**TOWN OF NEWBURGH  
PLANNING BOARD**

**PROJECT NAME:** UNITY PLACE WAREHOUSE  
**PROJECT NO.:** 21-29  
**PROJECT LOCATION:** NORTHWEST CORNER OF OLD LITTLE BRITAIN RD. & UNITY WAY  
SECTION 97, BLOCK 2, LOT 14.1, 19.12, 37.2  
**REVIEW DATE:** 14 JULY 2023  
**MEETING DATE:** 20 JULY 2023  
**PROJECT REPRESENTATIVE:** BROOKER ENGINEERING

**Unity Place Warehouse Application for Site Plan Approval**  
**Response Narrative to May 12, 2023 Review Comments prepared by Karen Arent**  
**prepared for Town of Newburgh Planning Board**  
**July 5, 2023**  
**BE #21202**

Re: **Unity Place Warehouse**  
Unity Place and Old Little Britain Road, Tax Lots: 97-2-14.1, 19.12, & 37.2  
Planning Board Project No. 2021-29  
BE #21202

**TITLE:** GRADING, DRAINAGE & UTILITY PLAN

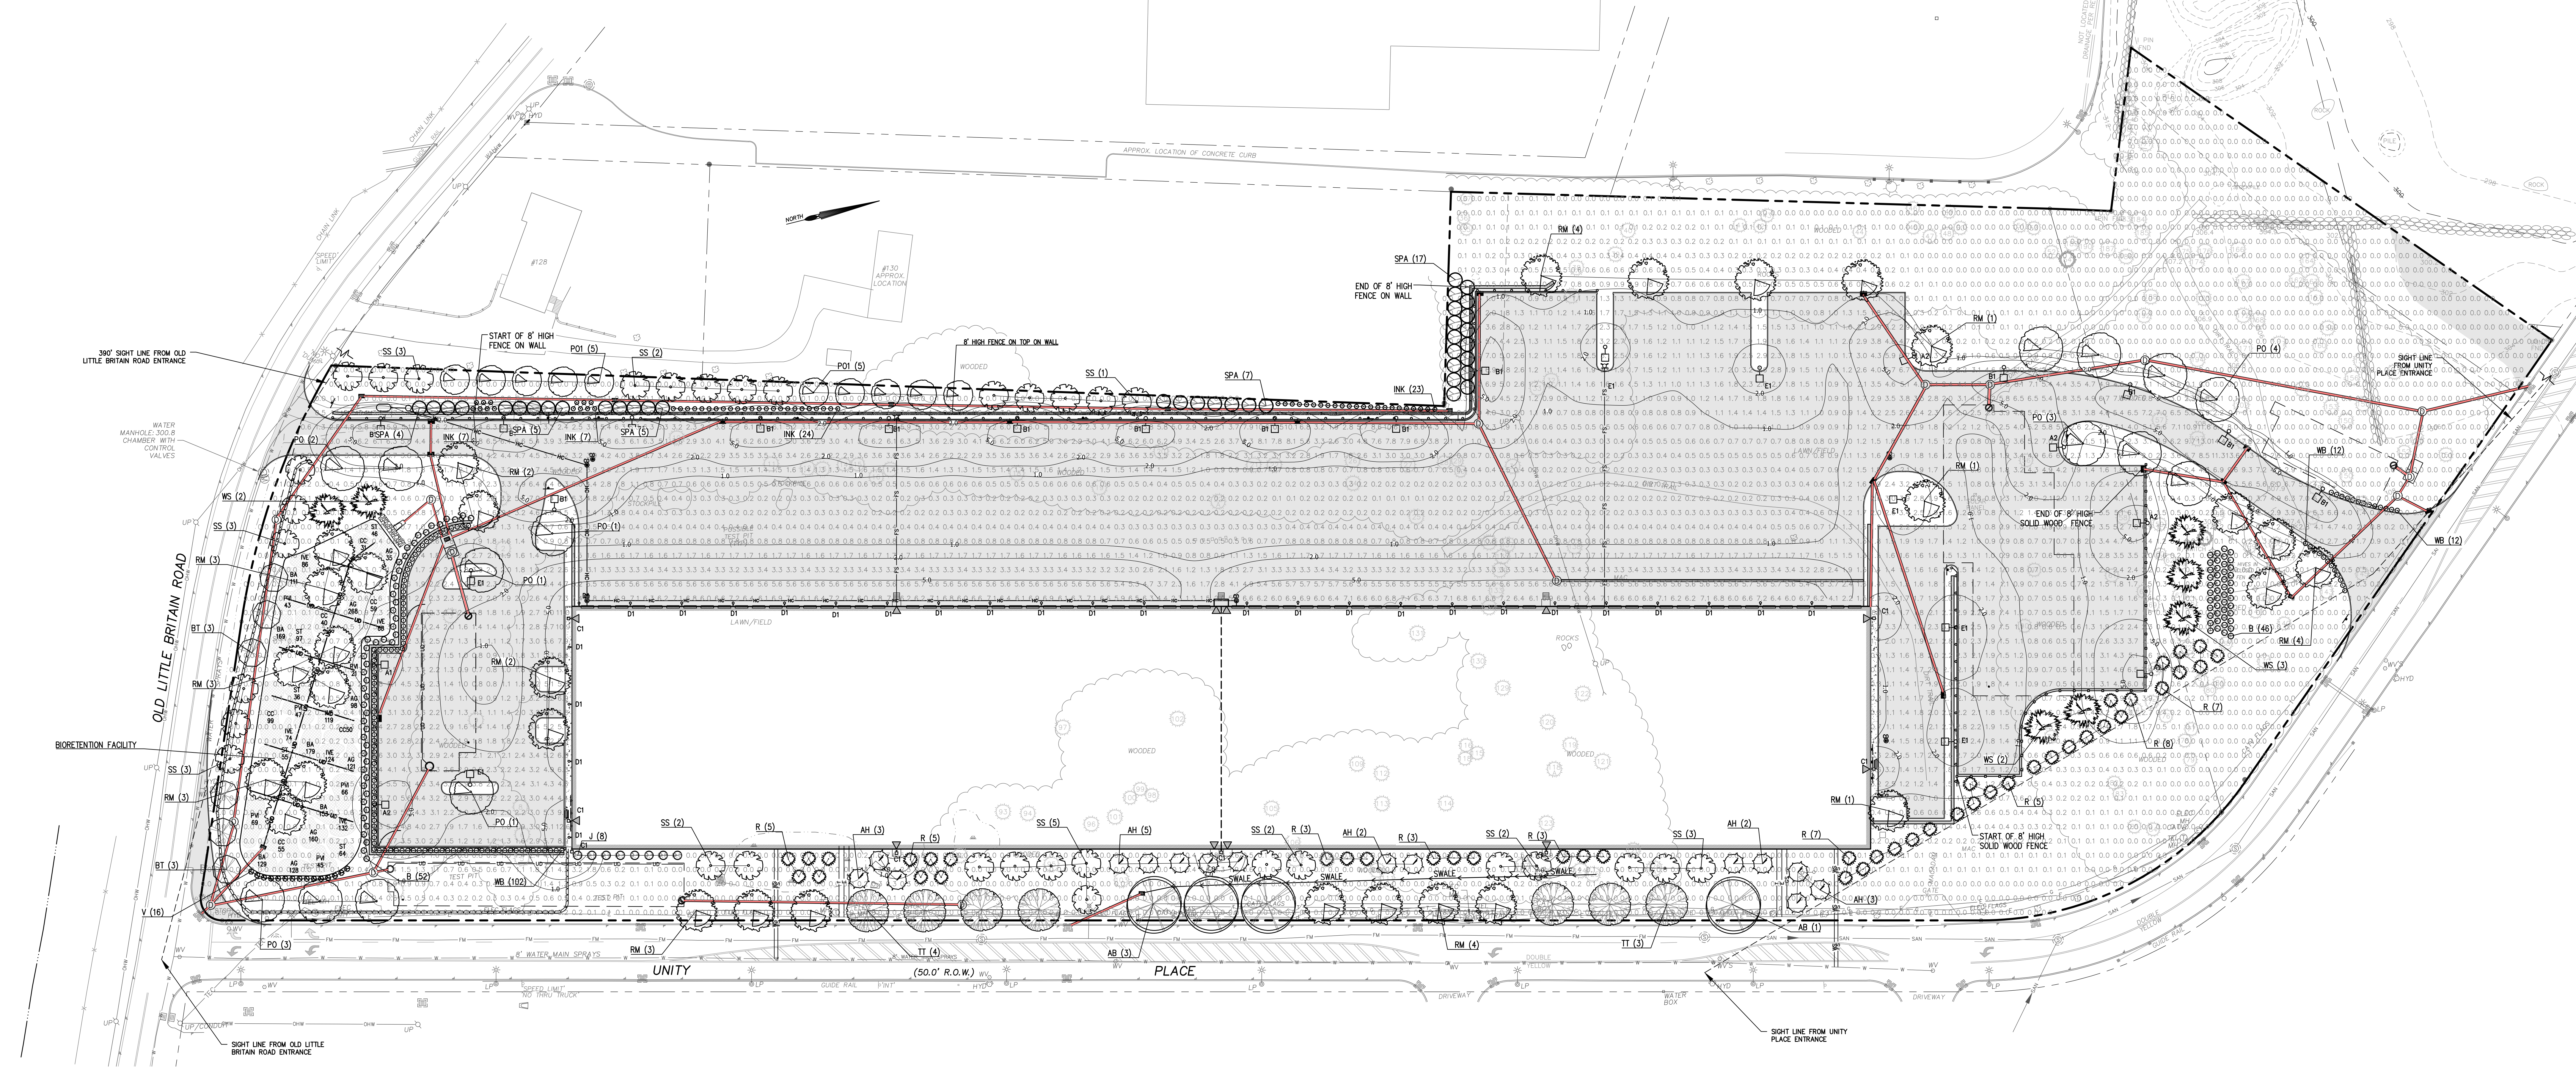
2. *COMMENT: Grading, Drainage & Utility Plan - Where does the existing Electrical Power Utility Line connect to the the new building? It is not shown or not shown clearly [i couldn't find it].*

**Response:** Two electric connections are proposed along Unity Place frontage as indicated on Sheet 3 of the Site Plan (Grading, Drainage, & Utility Plan). Designated as linetype with 'E' symbol.
